Errata to ANSI/TPI 1-2007

“National Design Standard for Metal Plate Connected Wood Truss Construction”

(7/15/2011)

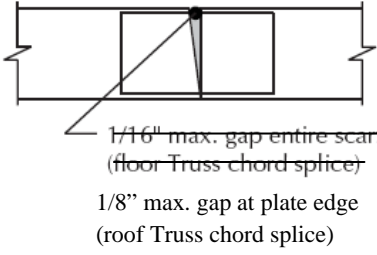
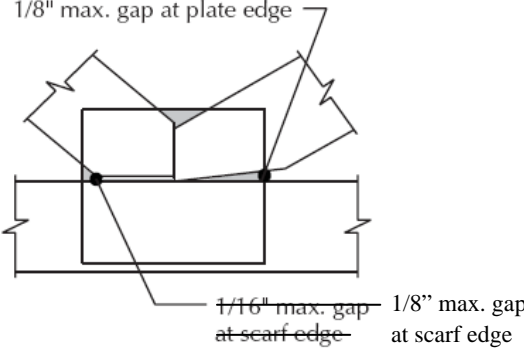
Page / Description	Correction
<p>Page 27 (Figure 3.7- 4) <i>The text for the lower splice detail is incorrect. This detail represents a roof Truss, not a floor Truss, and the maximum gap should be 1/8” at the plate edge, not 1/16” entire scarf.</i></p> <p style="text-align: right;">(7/13/2010)</p>	 <p>1/16" max. gap entire scarf (floor Truss chord splice)</p> <p>1/8" max. gap at plate edge (roof Truss chord splice)</p>
<p>Page 27 (Figure 3.7- 4) <i>The text for the web joint detail in the upper right corner is incorrect. The maximum gap at the scarf edge should be 1/8”, not 1/16”</i></p> <p style="text-align: right;">(7/13/2010)</p>	 <p>1/8" max. gap at plate edge</p> <p>1/16" max. gap at scarf edge</p> <p>1/8" max. gap at scarf edge</p>
<p>Page 27 (Section 3.7.7.1) <i>The referenced section should be 6.1.2, not 6.1.4.</i></p> <p style="text-align: right;">(7/20/2010)</p>	<p>... two times the minimum number specified for a single face by the Truss Designer per Section 6.1.4 6.1.2.</p> <p>...15% less than the number specified for a single face per Section 6.1.4 6.1.2.</p>

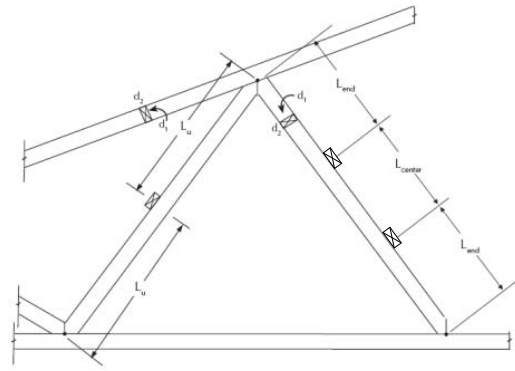
Page 60 (Figure 7.2-1)
 The figure does not show the continuous lateral restraints attached to the web on the right side.
 (7/20/2010)

Page 60 (Figure 7.2-1)
 The reference in the table above the figure illustrating Unbraced Lengths for Webs should reference Section 7.2.1 not 7.2.2.
 (2/17/2010)

Top Chord & Bottom Chord	d ₁	See Section 7.2.2 7.2.1
	d ₂	L _u

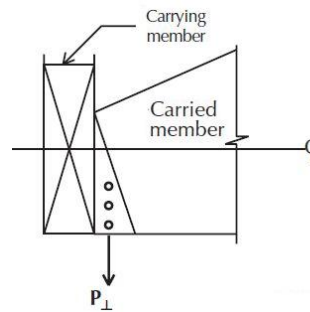
Page 69 (Figure 7.5-1)
 The right side figure should show the cross sectional member as the carrying member, and the sloping truss member as the carried member.
 (2/17/2010)

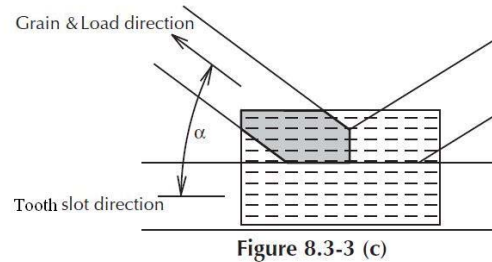
Page 77 (Figure 8.3-3 c)
 The label for the chord axis should be only "Tooth slot direction" and the label for the arrow on the shaded web should be "Grain and load direction".
 (2/17/2010)
